DWN	R.D.BILLING	09/30/04	PROJ ENGR	STRS		CHK	MATL		CONFIG	PROJ		ME	QA	
DWN	R.D.BILLING	09/30/04																									
PROJ ENGR	STRS																										
CHK	MATL																										
CONFIG	PROJ																										
ME	QA																										
20007845	1388	AL ALLOY 6061-T651 PER AMS-QQ-A-250/11		ALLIANCE SPACESHIELDS, INC. 1250 Lincoln Ave., Suite 100 Pasadena, CA 91103		BASEPLATE, STAGE 2 LIGO-047850-A		20007850		REV B																	
NEXT ASSEMBLY		APPLICATION		SCALE 1:4		UNCLASSIFIED		SHEET 1 OF 2		REV 704

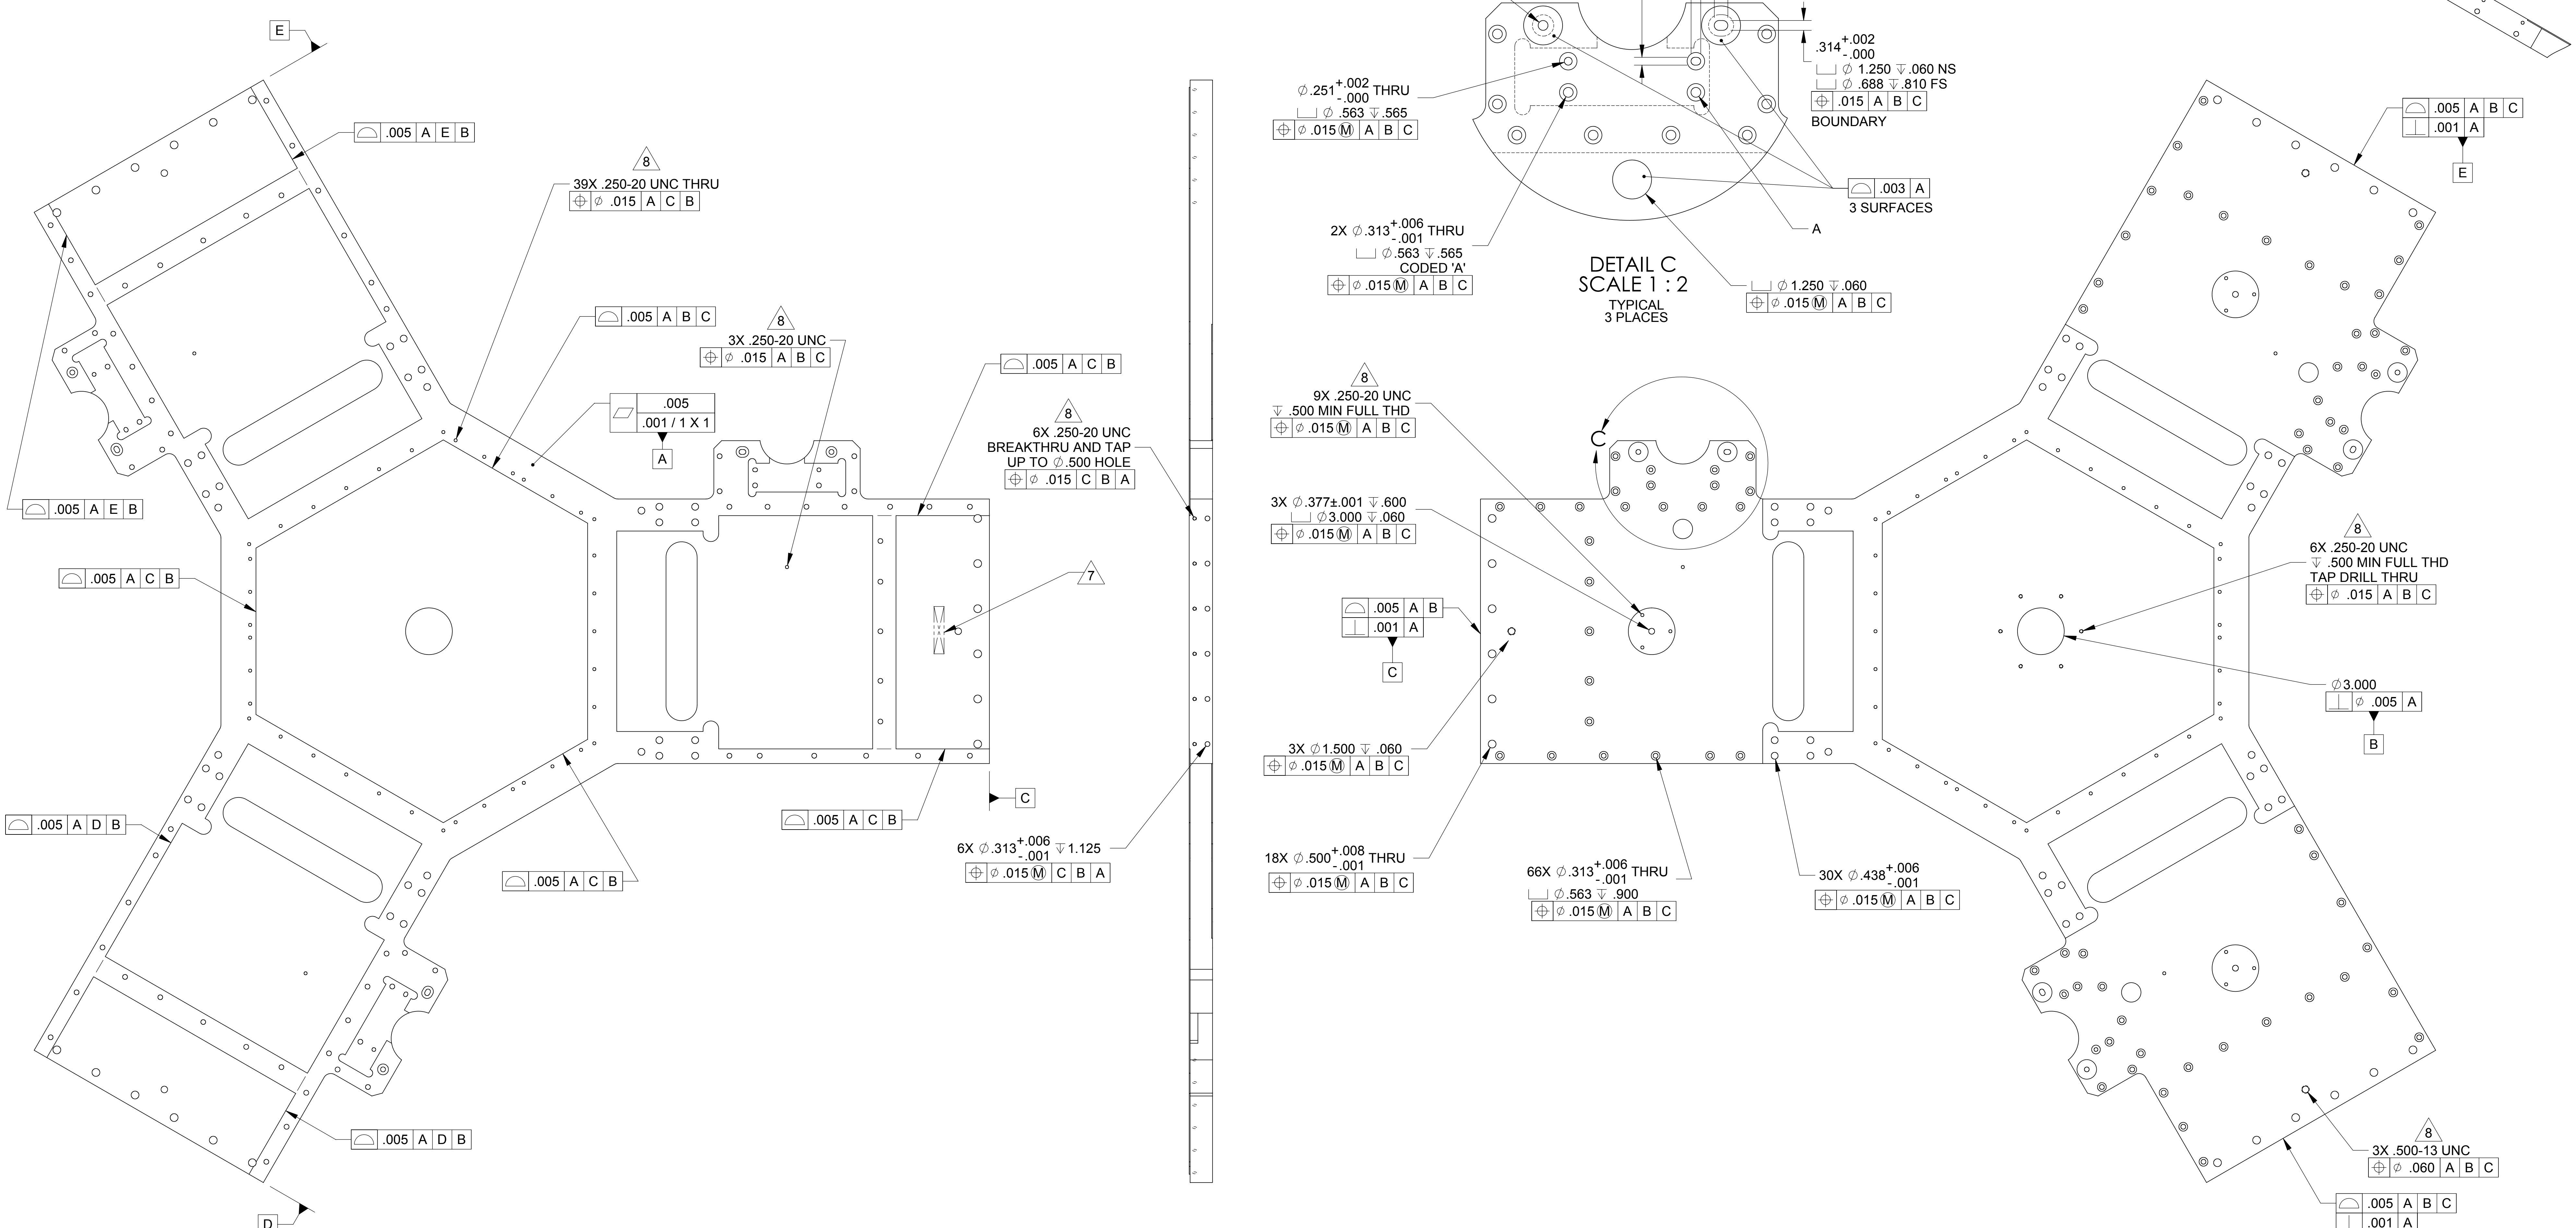
LTR		REVISIONS									
ZONE	DESCRIPTION	DWN	CHK	P-ENG	CONF	ME	STRS	MATL	PROJ	QA	RELEASE DATE
A	INITIAL RELEASE	RB	RF	KS	RF	RK	DCW	DCW	SV	GDL	10-06-04
B	MOVED 250-20 UNC HOLE (3 PL) DUE TO REDESIGN OF GS-13 HOLD-DOWN CLAMP	RF
